UNITED STATES PATENT AND TRADEMARK OFFICE

APPLICATION NO.	FILING DATE	FIRST NAMED INVENTOR	ATTORNEY DOCKET NO.	CONFIRMATION NO.
10/713,855	11/14/2003	Kenneth S. Solovay	GCC-106-CP1	1888
35996	7590	03/16/2006	EXAMINER	
LOTT & FRIEDLAND, P.A. ONE EAST BROWARD BLVD. SUITE 1609 FORT LAUDERDALE, FL 33301			MILLER, CHERYL L	
			ART UNIT	PAPER NUMBER
			3738

Office Action Summary

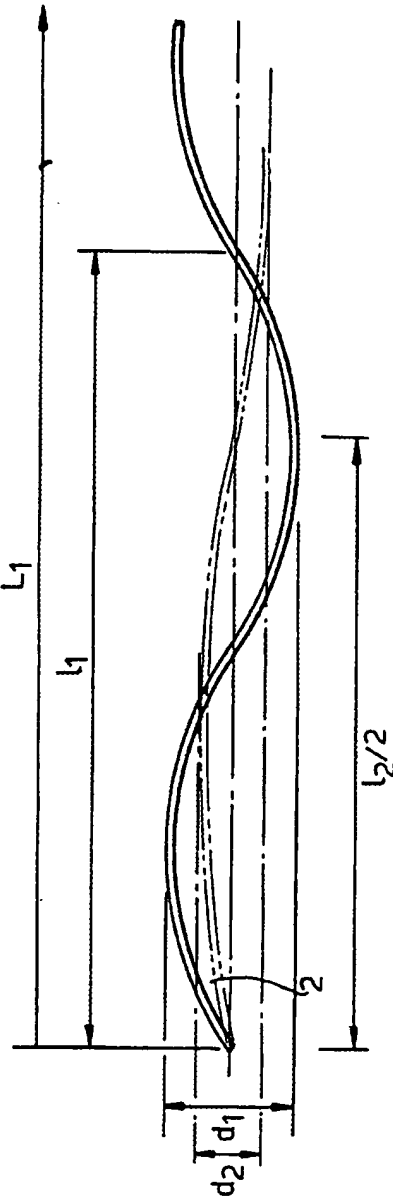
Claims 1-4 are rejected under 35 U.S.C. 102(b) as being anticipated by Taylor et al. (US 6,083,257). Taylor discloses a rail stent graft (1; fig.1) comprising an elongated stent assembly comprising at least one vessel support element (proximal end of stent 4) *positionable* on a first side of a junction of two vessels (is capable of being positioned at such a location), an elongated stent-graft assembly comprising at least one vessel support element (distal end of stent 5) and at least one graft element (graft disclosed to cover entire stent 1, which includes the distal end; col.7, lines 30-38), the stent-graft assembly being *positionable* on a second side of a junction of two vessels (is capable of being positioned at such a location), and at least one rail element (one filament 3) extending between the stent assembly and the stent-graft assembly (see attachment 1), each assembly movable along and relative to the rail element (slidable, col.4, lines 27-30).

Attachment #2 (marked up)

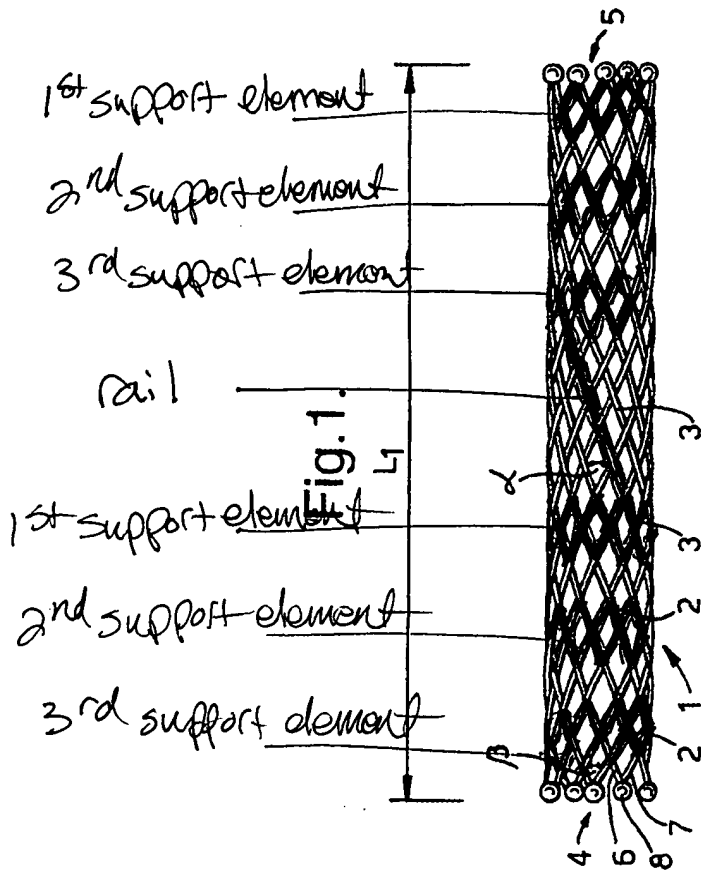
Taylor discloses circumferential rings (1st, 2nd, and 3rd supports, see attachment 2) spaced on an axis, wherein the rail element (filament 3) is received in the rings (attachment 1, 2).

Taylor discloses a plurality of vessel support elements (see attachment 2), wherein the supports are circumferential in cross-section.
